# Wollongong Local Planning Panel Assessment Report | 5 September 2018

<b>WLPP No.</b>	Item 2
<b>DA No.</b>	DA-2018/533
<b>Proposal</b>	Residential - dual occupancy and Subdivision - Strata title - two (2) lots
<b>Property</b>	7A Cochrane Road, THIRROUL NSW 2515 Lot 12 DP 1188169
<b>Applicant</b>	Plannex Environmental Planning
<b>Responsible Team</b>	Development Assessment and Certification – City Wide Team (JW & VL)

## ASSESSMENT REPORT AND RECOMMENDATION

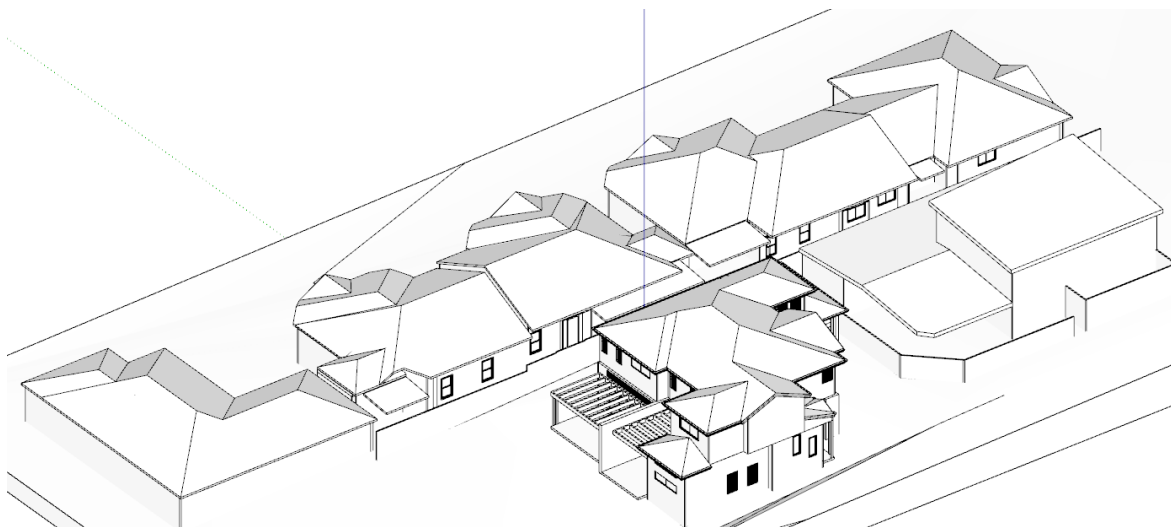
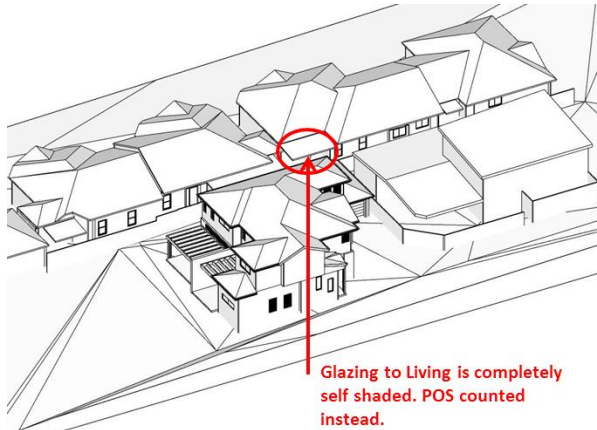
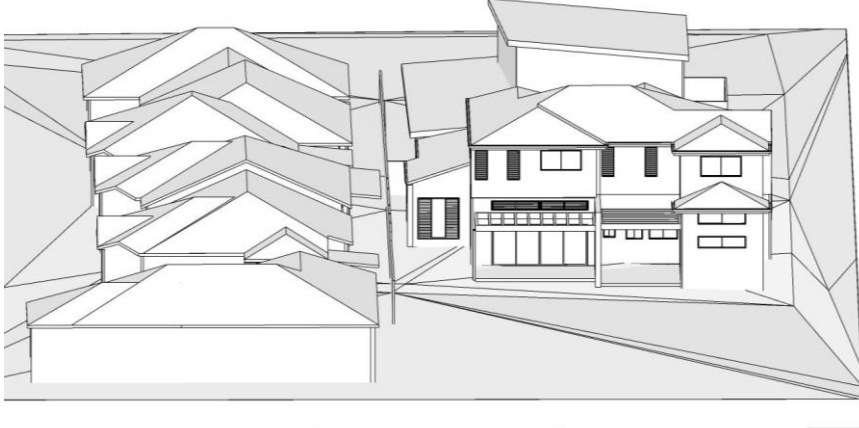
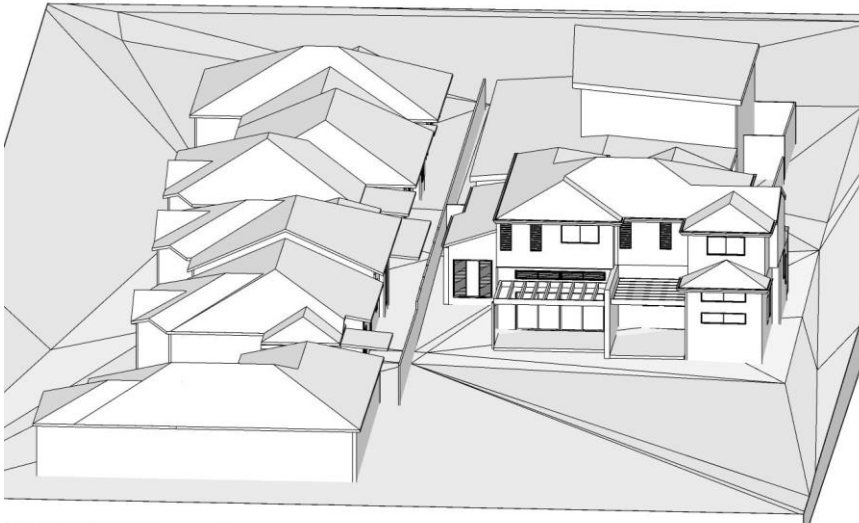
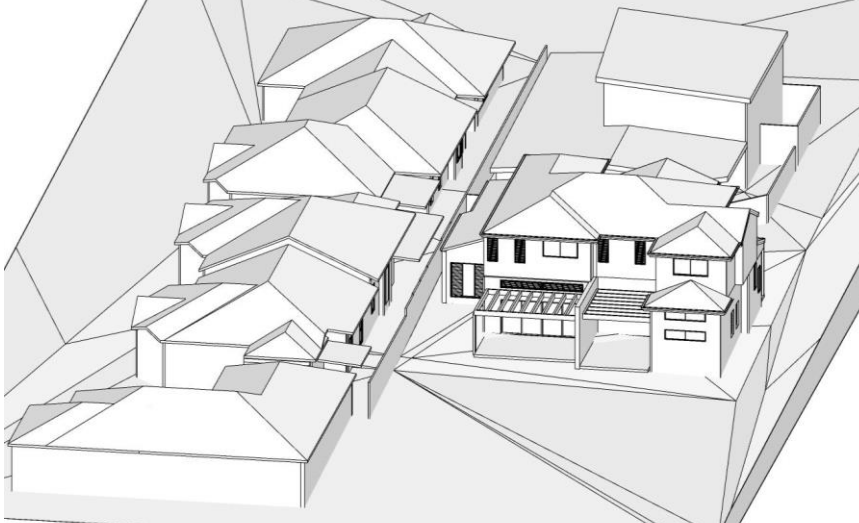
***Summary inspection of the views from the sun lets me conclude that all potentially impacted glazing at No.5 retains complying amounts of solar access at least from 9:30 AM till 12:30 PM.***

With the exception of the covered private open space highlighted in Figure 2 all other outdoor space at ground level is completely self shaded in winter by the boundary fence. The proposed design appears to have been carefully configured to cast approximately the same shadow as the fence.

***Analysis of the potential overshadowing impact on the neighbours appears to clarify that the proposed design retains a minimum of 3 hours of direct sun to all potentially affected glazing – and therefore the proposal meets the relevant DCP control for overshadowing.***

Attachment 5 - Shadow diagrams from DA-2017/980

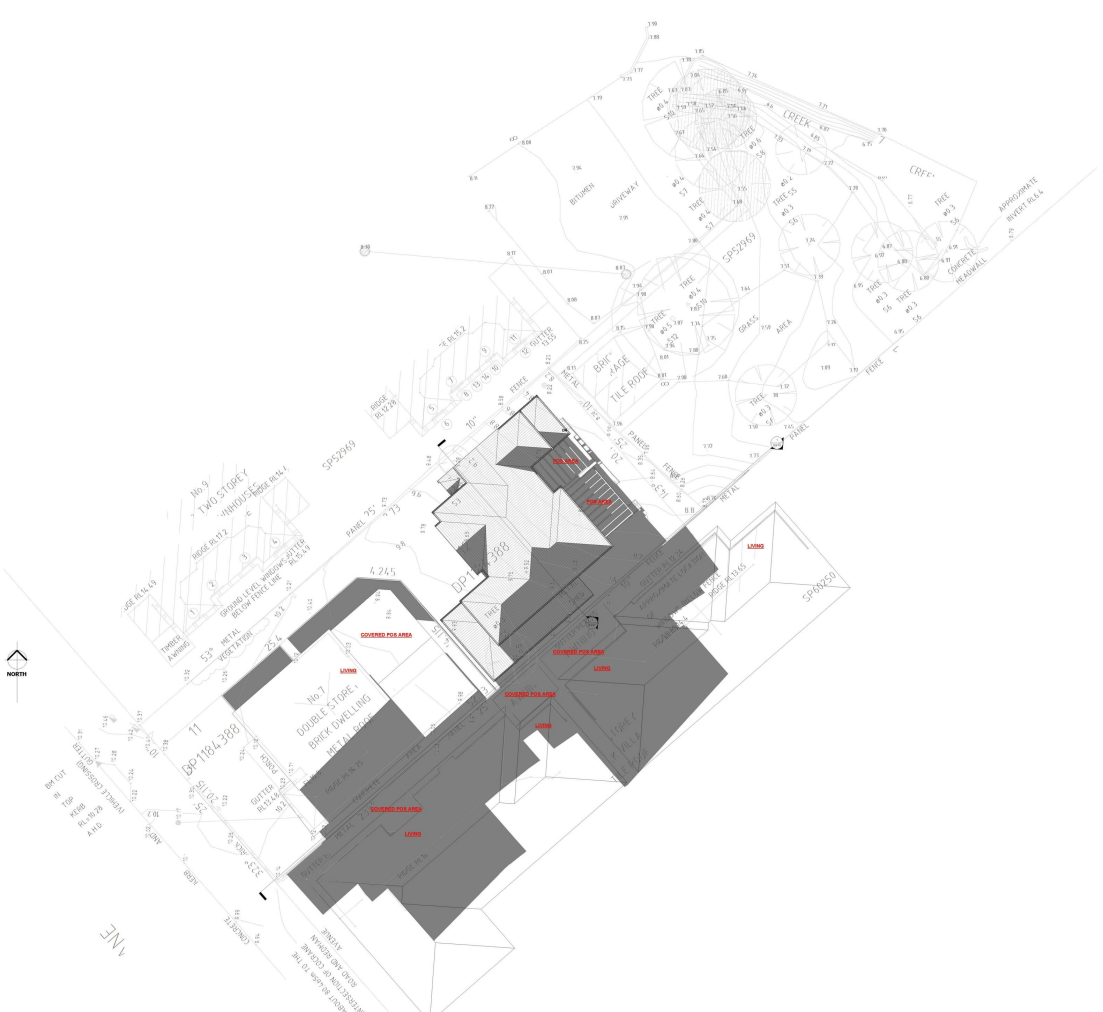
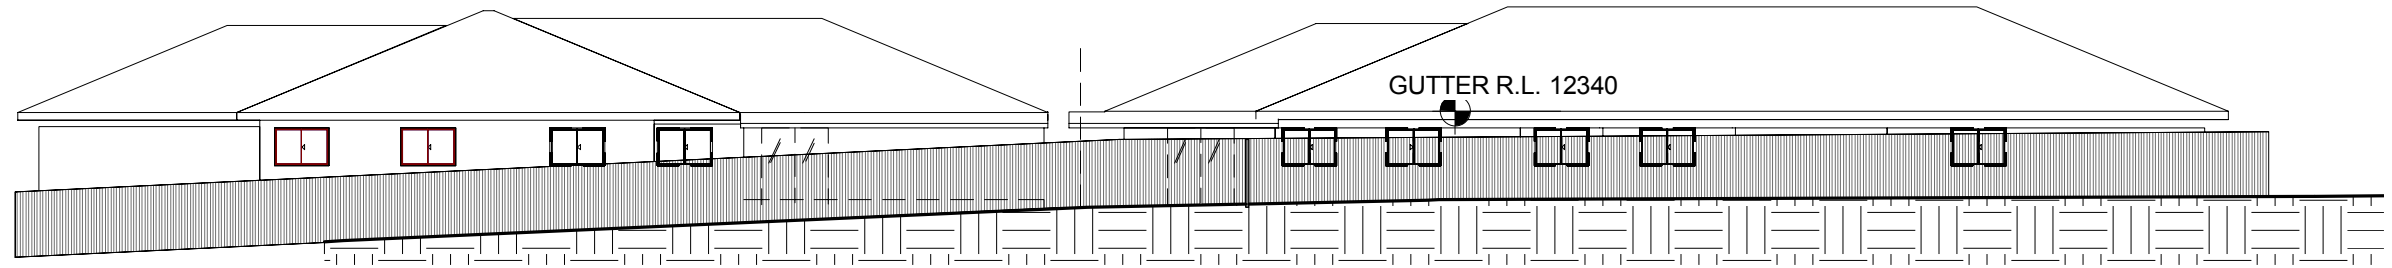
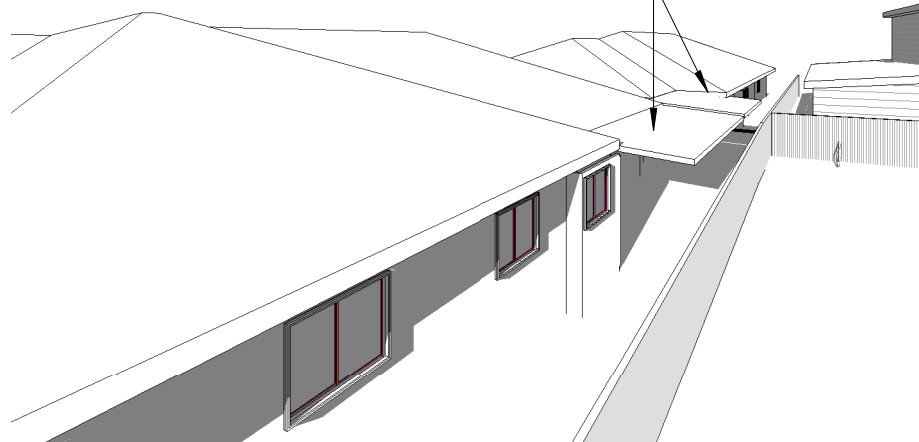
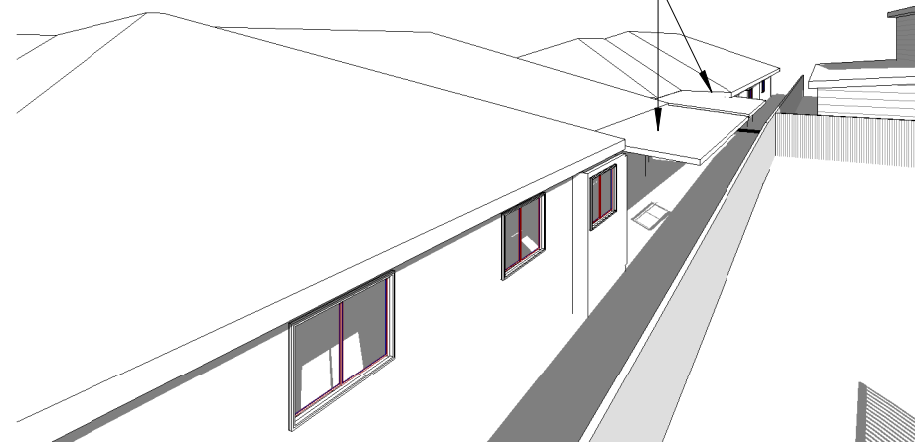
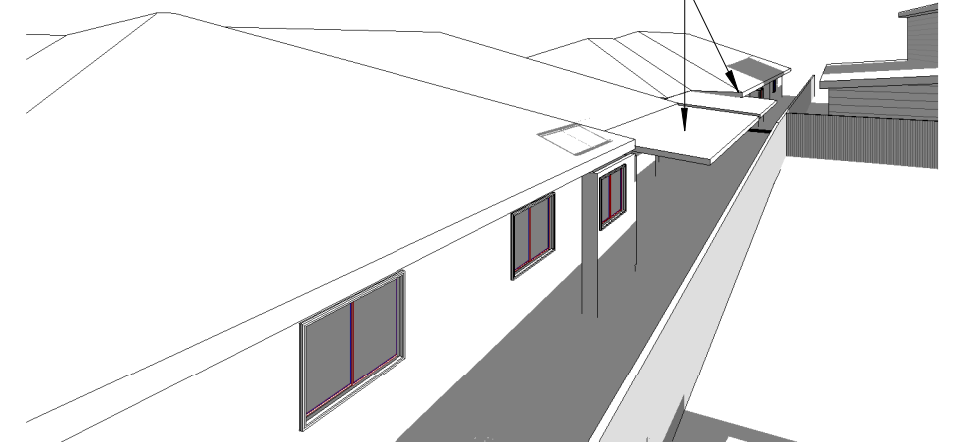
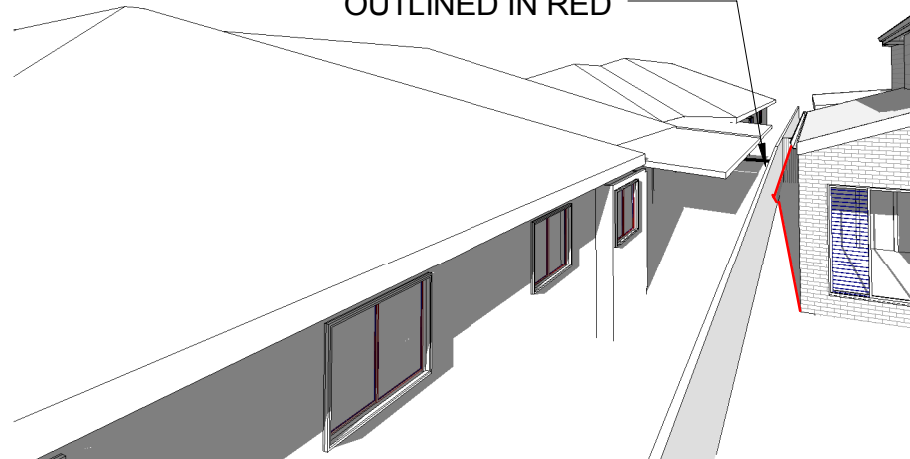
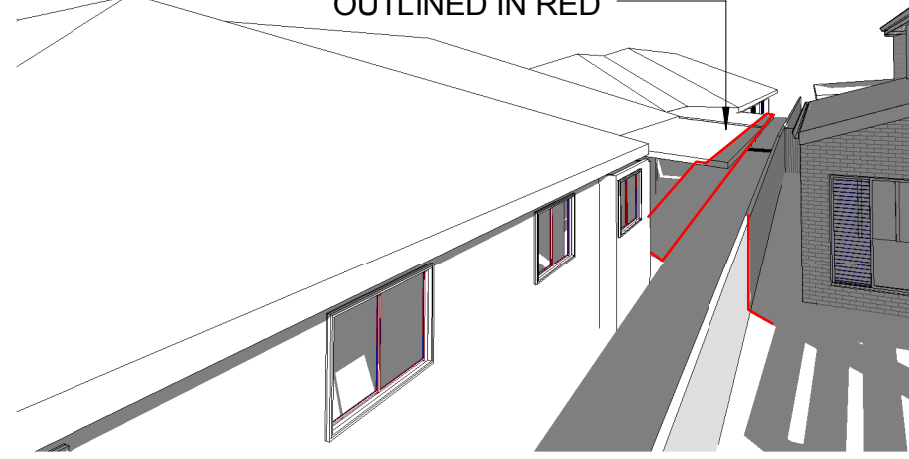
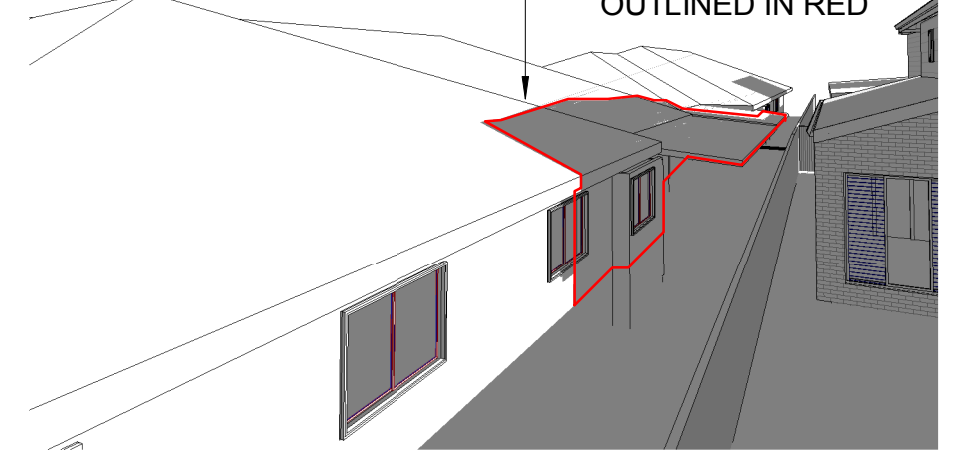
The overshadowing analysis concludes that the *"analysis of the potential overshadowing impact on the neighbours appears to clarify that the proposed design retains a minimum of 3 hours of direct sun to all potentially affected glazing – and therefore the proposal meets the relevant DCP control for overshadowing"*.
